# **Beaches Link and Gore Hill Freeway Connection**

Appendix C1 –  
Responses to submissions on marine construction activities, sediment and water quality

Project Name : Beaches Link and Gore Hill Freeway Connection  
Date : 22 June 2021  
Our reference : PA1694-104-100-N001F01-BL&GH connection  
**Subject** : Submissions report –  
Responses to submissions on marine construction activities,  
sediment, and water quality

Appendix C2 -  
Review of recreational exposures  
during dredging activities

Figure 1 Locations adopted based on locations of interest identified in submissions

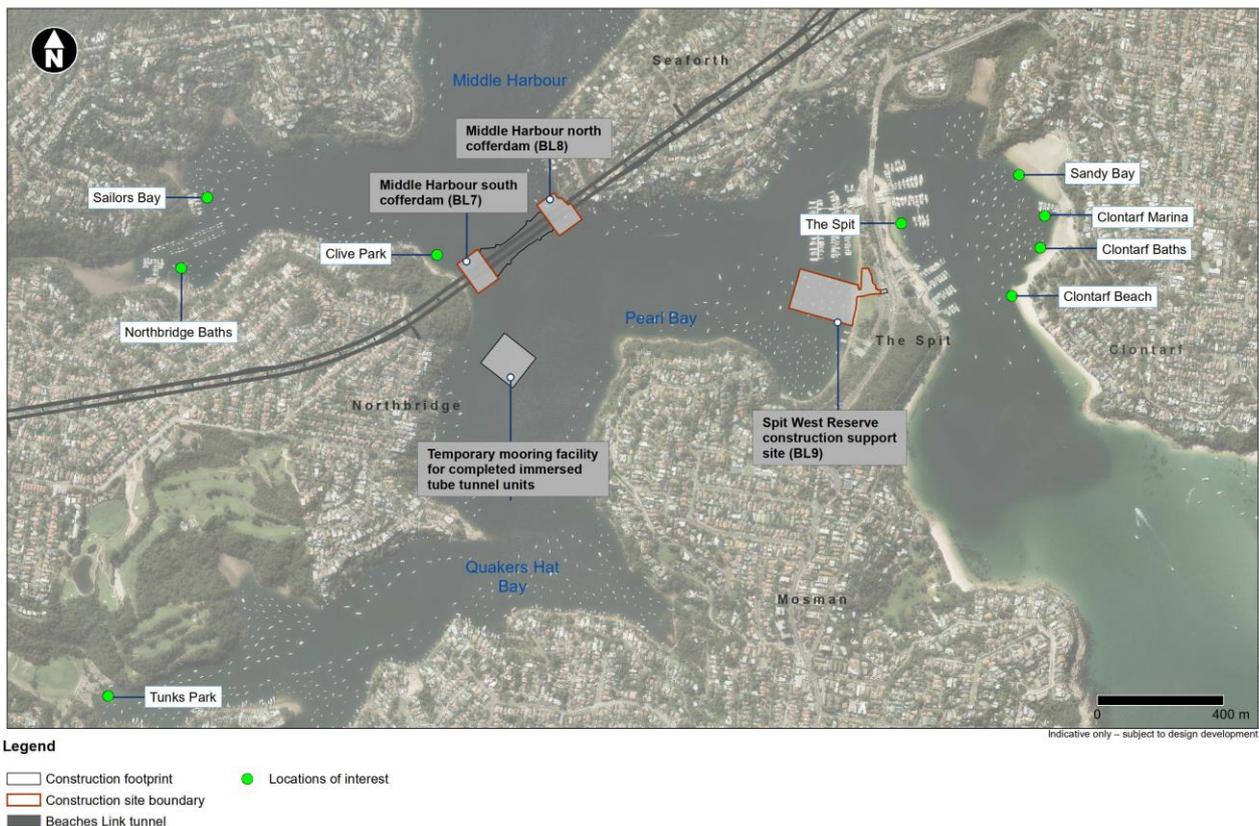
**Concern about disturbed contaminated sediment polluting the harbour and making it unsafe for recreational users of Middle Harbour including users of Clontarf Beach, Clontarf tidal pool, Clontarf Marina, Northbridge Baths, Sandy Bay, The Spit, Clive Park, Tunks Park and Sailors Bay.**

*The main locations of interest identified in submissions are shown in Figure 1 below.*

The SSC at the locations of interest have been extracted from the modelling results for the duration of the dredging activities (37 weeks). The value of SSC at any location varies over time due to a number of factors:

**Figure 1 Project construction areas and recreational locations of interest in Middle Harbour (Source: RHDHV memo dated 22 June 2021)**

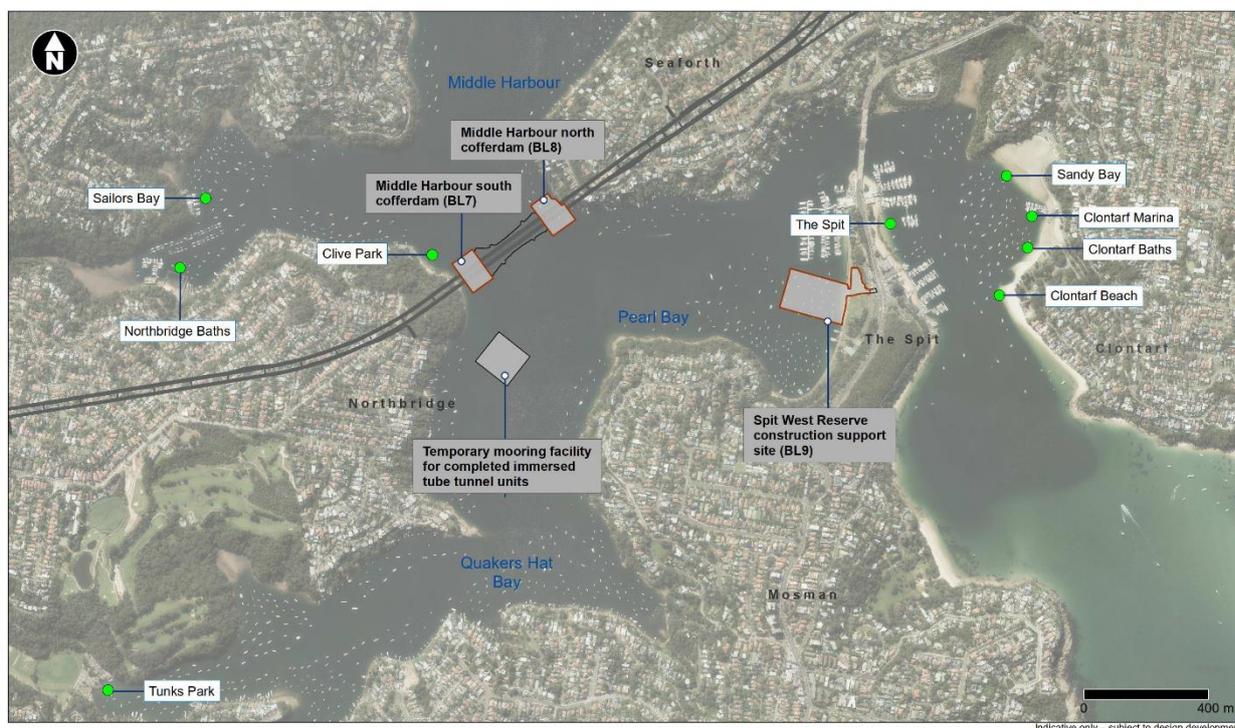
This memo has been prepared in response to matters raised in submissions on the Beaches Link and Gore Hill Freeway Connection project (the project) environmental impact statement, and presents further review of potential recreational exposures that may occur during proposed dredging activities for the project.

There are a number of existing recreational areas identified by the community and government agencies in the vicinity of the proposed works in Middle Harbour. These recreational areas are shown in Figure 1. The project involves an immersed tube tunnel crossing of Middle Harbour from Clive Park, Northbridge in the south to Seaforth Bluff, Seaforth in the north.

Review of Table 1 indicates that all maximum (or worst-case) concentrations of chemicals in water, as a result of the presence of suspended sediments or dissolved phase concentrations from dredging activities, are well below (at least 1000 times below) recreational water guidelines.

This table relates to predicted worst-case concentrations at the closest recreational area of Clive Park. Concentrations in all other locations, which are further away from the construction footprint, will be lower due to increased dilution or mixing in larger volumes of water.
